Access Compliance Report

Public Rights-of-Way

Intersection ID: 19993	Main Street: ARCHDALE_DR	Cross Street: INGLESIDE_DR	Location: SW
ADA ID: A946E0DCF9D2	Ramp Type: PerpDiag	Initial Pass/Fail: Fail	Overall Compliance: No
		Severity Score: 10

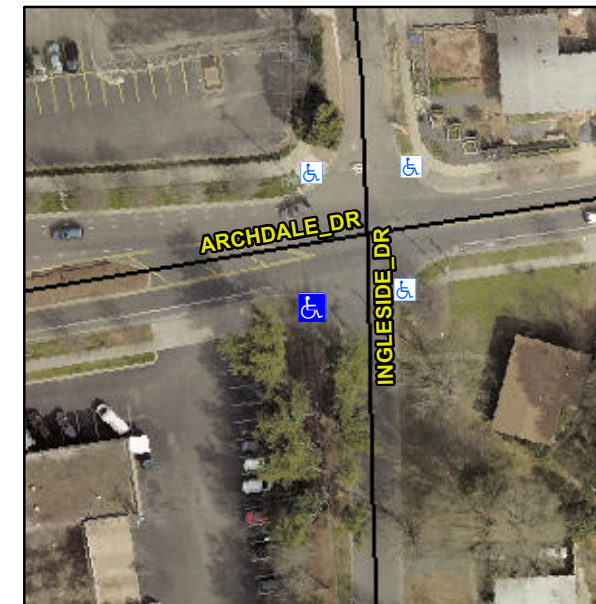
Not Found, R304.5.1, R304.5.3

Compliance	Description	Data	Compliance	Description	Data
N/A	Ramp Length (in)	96.0	Yes	Ramp Slope (%)	7.8
No	Ramp Width (in)	46.0	No	Ramp XSlope (%)	2.1
N/A	Flare Type LT	N/A	N/A	Flare Type RT	N/A
N/A	Flare Slope LT (%)	N/A	N/A	Flare Slope RT (%)	N/A
N/A	Flare Traversable LT?	N/A	N/A	Flare Traversable RT?	N/A
N/A	Landing Length (in)	N/A	N/A	DWS Provided?	N/A
N/A	Landing Width (in)	N/A	N/A	DWS Contrast?	N/A
N/A	Landing Slope (%)	N/A	N/A	DWS Length (in)	N/A
N/A	Landing X Slope (%)	N/A	N/A	DWS Full Width?	N/A
N/A	Landing Curb? (Y/N)	N/A	N/A	DWS Offset (in)	N/A
N/A	Shared Landing?	N/A			
N/A	Gutter Ponding?	N/A	N/A	Gutter Slope (%)	N/A
N/A	Gutter Lip Ht (in)	N/A	N/A	Gutter X Slope (%)	N/A
N/A	Painted X Walk1?	No	N/A	Painted X Walk2?	No
	X Walk 1 Direction	To E		X Walk 2 Direction	To N
N/A	X Walk 1 Width (in)	N/A	N/A	X Walk 2 Width (in)	N/A
	X Walk 1 Slope (%)	2.8		X Walk 2 Slope (%)	1.1
	X Walk 1 X Slope (%)	1.6		X Walk 2 X Slope (%)	1.9

Remove & Replace Curb Ramp With Two New Directional Ramps or Equivalent.
